CALIFORNIA COASTAL COMMISSION

STAFF REPORT: REGULAR

Appeal Number	A-3-SLO-00-119
Local Government	San Luis Obispo County
Decision	Approved with conditions, 047/07/00
Applicant	Joe Todd
Appellants	Commissioners Sara Wan and Pedro Nava
Project Location	16485 Cabrillo Highway (approx. 1.5 miles north of Piedras Blanca Lighthouse, North Coast Area Plan), San Simeon (San Luis Obispo County) (APN 011-231-001)
Project Description	Construction of an approximately 2,980 sq. ft. single family dwelling with attached 720 sq. ft. garage, and 1,200 sq. ft. barn.
File Documents	San Luis Obispo County Certified Local Coastal Plan; Coastal Development Permit D990190P; COAL 90-137.
Staff Recommendation	Denial

ELEVATIONS

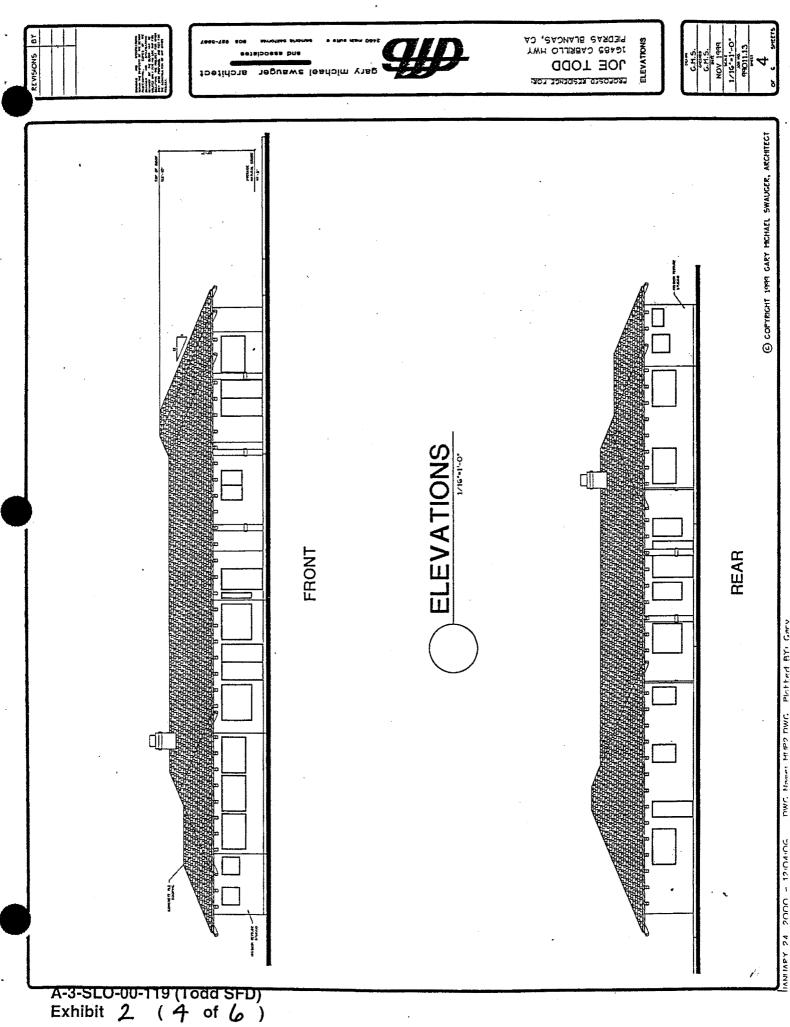
As proposed, the residence and barn are approximately 15'6" in height. Vegetative screening is proposed to help shield the residence from view of northbound travelers on Highway 1: however, the barn will be fully exposed to these viewers, and potentially in partial view of southbound travelers. It should be acknowledged that the applicant and the County have worked toward minimizing the visual impacts of the development itself, including the use of lower-house design, appropriate colors, and vegetative screening as a mechanism to shield the residence from public viewing areas. Nonetheless, these measures are not adequate to ensure that the extremely sensitive rural viewshed of the North Coast will forever be preserved to the maximum extent feasible. Every reasonable effort must be made to assure that new development in this area is truly subordinate to. and blended with the rural landscape. Again, although vegetation can be effective in some instances, when used in areas such as the vast, rolling hillsides and grasslands found along this stretch of coast, it may create an unnatural look and has an impact, equivalent to that of a structure, on the visual and scenic qualities of this area. The Commission also notes that the design and material used in the driveway to the building site as presently proposed will blend into the landscape during the dry periods of the year when the hills are golden brown but will be obtrusive during the season when the hills are green. (See Exhibit 6.) The use of a paving material, such as turf block, that allows for this seasonal color change may be worthy of consideration in a re-designed project.

There is no question that Visual Policy 4 of the San Luis Obispo LCP sets a high standard for protection of the extreme visual sensitivity of the North Coast. A traditional house design such as that proposed by the applicant does not readily blend in with, nor is it subordinate to, the rural character of the area. Thus, the project as currently proposed is not consistent with Visual Policies 1 and 4. However, alternative home designs are available that would at once minimize the intrusion of unnatural structures and vegetation into this environment and that also allow for reasonable single family living. For example, a berm of approximately 6 feet in height could be constructed on the applicant's parcel, behind which a residence could be hidden from view. Based on analysis of existing contours on and around the project site, a six-foot high berm with slopes of 10-15% would not significantly detract from the surrounding landscape and is feasible to construct on the site. In conjunction with a lowered site grade of approximately 4-5 feet, this berm height limit would allow for construction of a house of reasonable height while meeting the objective of subordinating development to the rural character of the area. landform alteration would be required, such alteration, if done appropriately to blend in with existing contours, would be preferable to unnatural vegetative screening.

Exhibit 3 (1 of 2)

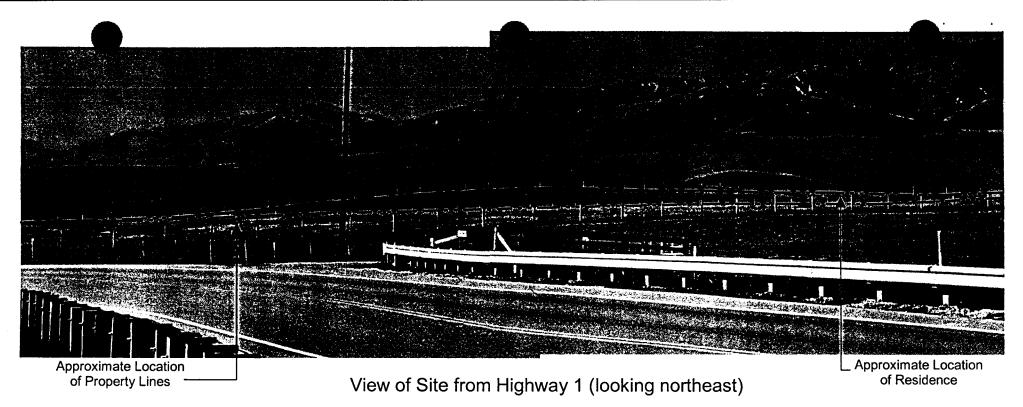
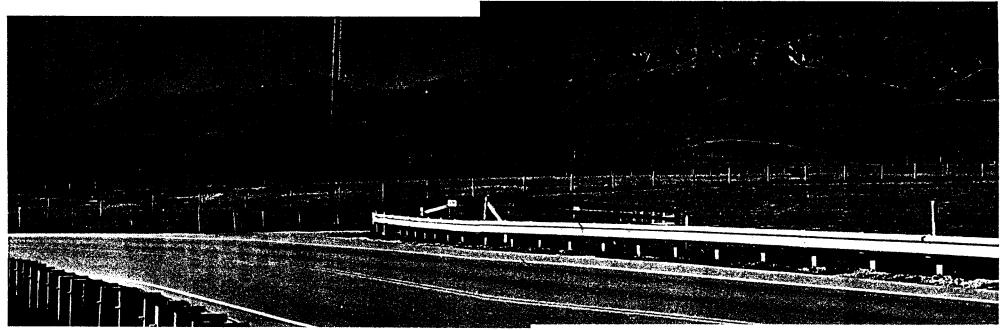
Obispo Coastal Zone are not a part of the natural landscape along this portion of the north coast although some trees have been planted over the years to provide shade and act as wind breaks. Exhibit 3 depicts the open character of this area. This entire sweep of open, rolling hillsides and unspoiled landscape against the majestic backdrop of the Santa Lucia Mountains can be viewed by the public in a continuously unfolding panorama along Highway 1. Indeed, there is perhaps no reach of coast in California that is more visually sensitive than the North Coast of San Luis Obispo. This southern gateway to Big Sur is a powerful landscape of incomparable and stunning beauty that is extremely vulnerable to degradation by new development because of its open character, long vistas and lack of natural screening vegetation. The Commission recognized this most recently during its review of the San Luis Obispo County North Coast Area Plan Update (approved May 13, 1998), finding that the North Coast is "regarded as a scenic coastal resource of great public importance." The findings go on to observe the following in regard to the character of Hearst Ranch and the surrounding area:

There is no question that the current development proposal would significantly impact the scenic quality of the rural and rugged North Coast. As shown in Exhibits 3 and 6, the proposed development would be located in the middle of an undeveloped, open expanse of agricultural lands west of Highway 1 typical of this stretch of coast. The potential for three similar proposals immediately south of the project site raises concerns about the cumulative impact of development and its associated landscaping and landform alteration on this coastal terrace. Although some development can be seen from Highway 1 in this general area (i.e. Piedras Blancas Motel, Hearst Ranch residence), these buildings were constructed prior to adoption of the Coastal Act. They also provide evidence of the visual impacts that can result from inappropriately designed development in this sensitive area. (See, for example, the photos of the motel in Exhibit 6.) Moreover, given the scenic nature of this stretch of coast, it is that much more important to limit any additional development that would break up expansive views of the rolling hillsides and incrementally degrade the rural character of the North Coast. Thus, the greatest possible effort must be put forth to safeguard this area from the intrusions of new development.

FIGURE 8

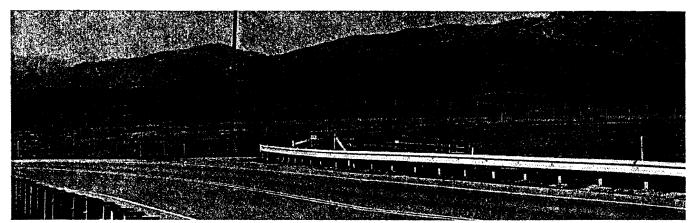
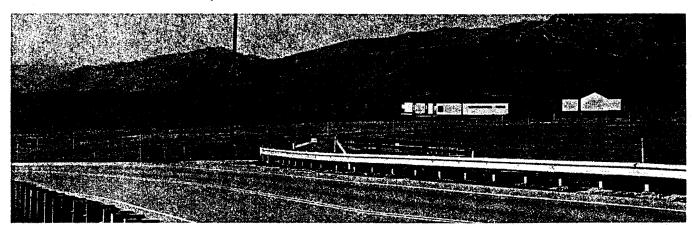
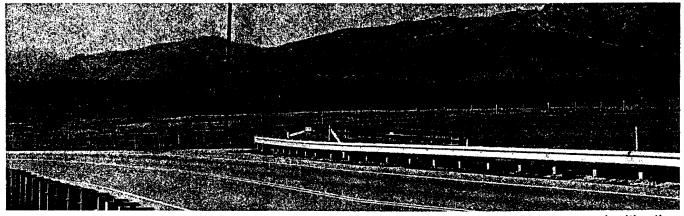
The Applicant has recently submitted a visual analysis that illustrates this concern. (Please see Exhibit 6.) The analysis includes three photos of the same view of the site from Highway One (existing landform, existing landform with proposed structures, existing landform with proposed structures and vegetative screening). The depiction of the proposed dwelling screened by trees shows how the natural, open grassland landscape will be altered by the incongruous placement of a line of trees leading up from Highway One up to an unnatural appearing grove of trees encircling the house site. This screening, because it uses plant materials that are not generally seen in the context of this open landscape, serves to focus the viewers eye on this site rather than provide a setting that causes the proposed development to recede into the landscape and be visually unobtrusive and subordinate to its setting. An additional problem with the use of trees as screening material is that with age, the tree canopy that provides the most effective screening will often grow above the structures it was designed to obscure. The structures at that point become visible once again. (See, for example, Exhibit 6 showing the existing farmhouse to the south of this property surrounded by mature Cypress trees.) However, while the LCP also requires that landform alteration be minimized, it does allow such alteration if done in way to blend with adjacent natural terrain (Visual Policy 5). As discussed below, siting and design options that rely on natural-looking berms, rather than vegetative screening, best
